**ACME TOWNSHIP PARKS & TRAILS MEETING**  
**SAYLER PARK: PAVILION #1**  
**5923 Yuba Park Road, Williamsburg MI 49690**  
**Monday, July 20, 2020 4:00 p.m.**

**F. OLD BUSINESS:****1. Bayside Playground Expansion**

**Subject:** Playground

# Acme Township North Bayside Park

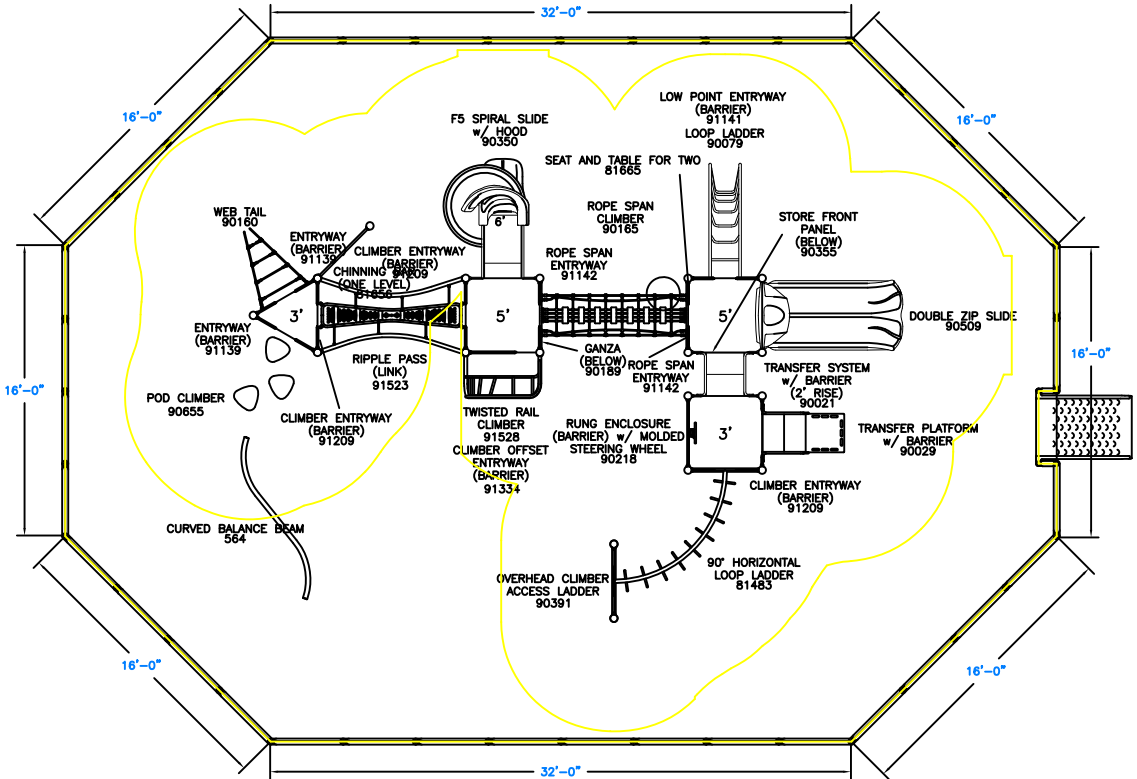
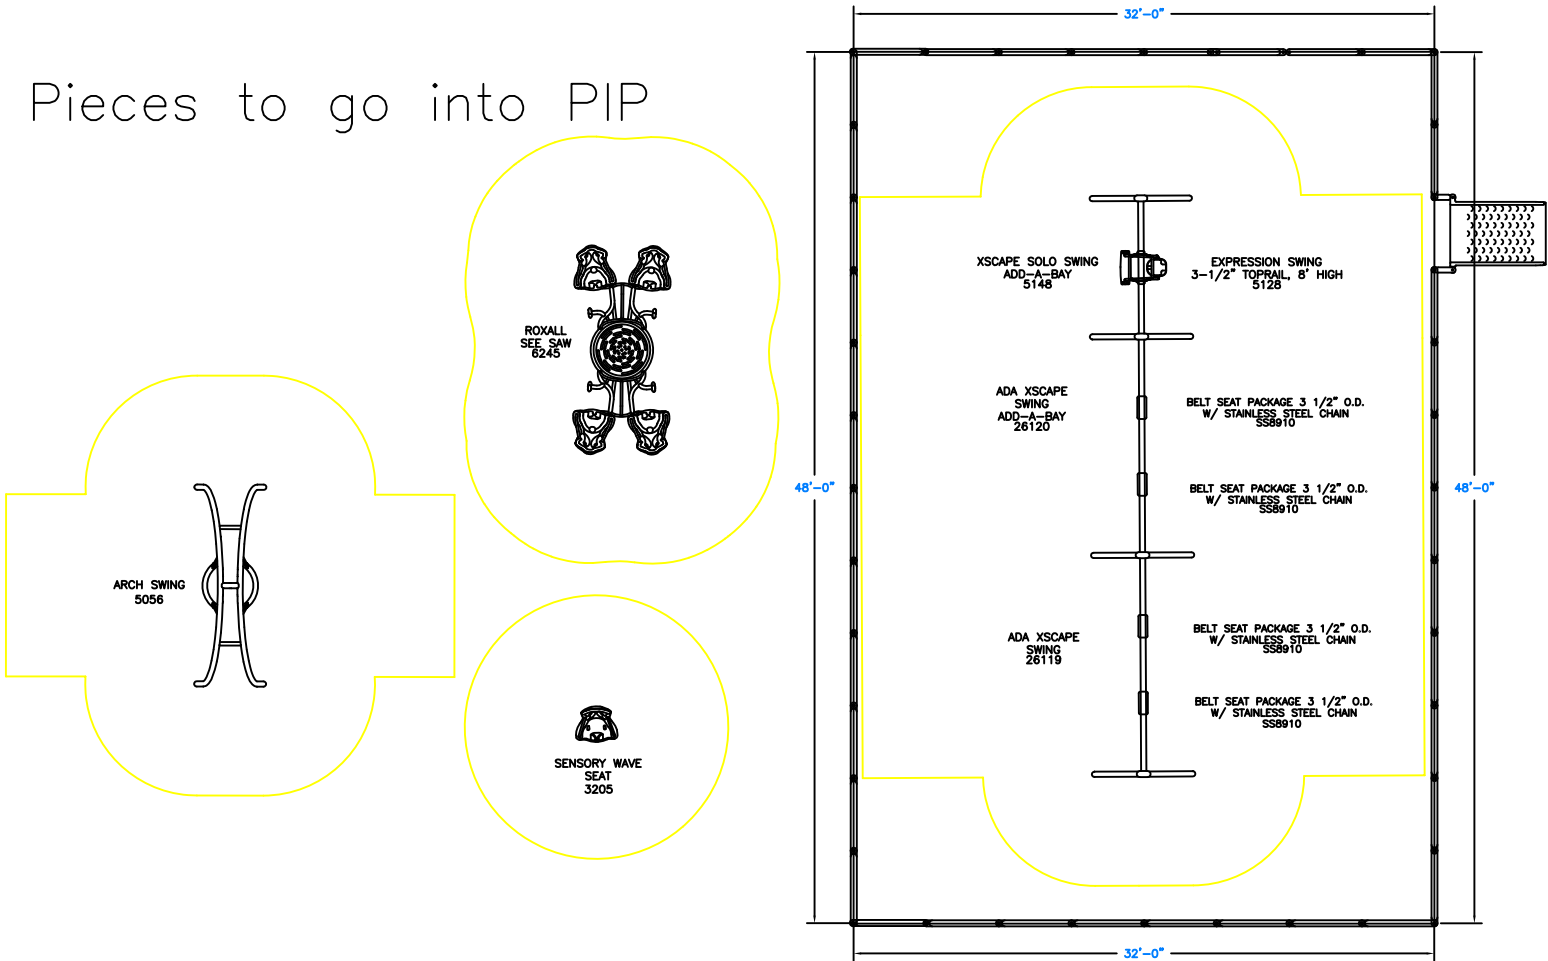
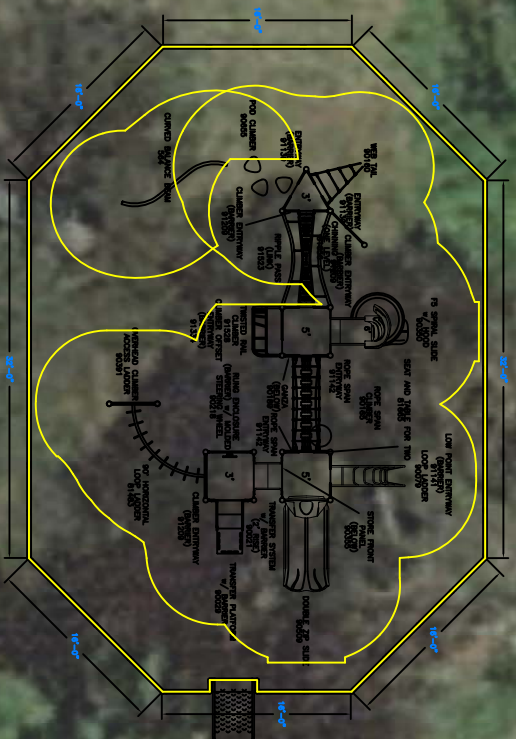
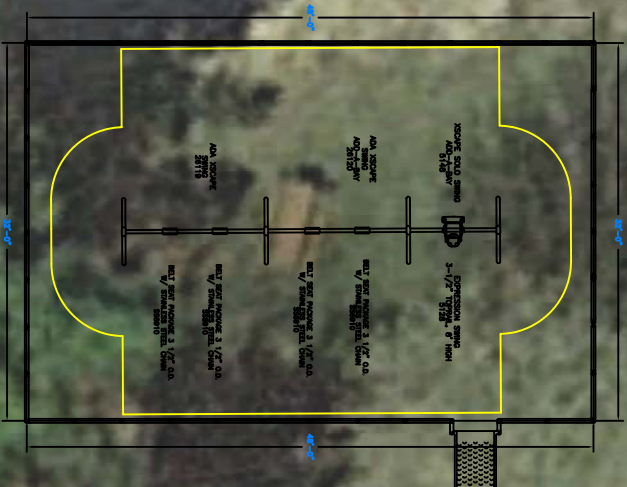
With the estimate we have questions

PIP and EWF are both on the quote, would we choose one and that would adjust the total?

We want to extend the sidewalk as part of this project and have a few areas that are ADA compliant for some of the fixtures, but the rest would be EWF is that possible?

We had talked about extending the sidewalk south along the east side of the net climber and building the playground area out to the south. The objects that are ADA compliant or accessible would be along the sidewalk with EWF connecting them. We want to work around trees, there is one ash that we are fine removing, but would like to incorporate the plan in to the rest of those, how do we do that?

4 person teeter totter, we like the linear 4 person one, but not the quad one

rope V on a beam

not super excited about the color scheme, with the stock colors we feel they are too bright, we would like to make it more neutral. With grey, blue and white

we want the whole structure to look a little more open. a little more clear view.
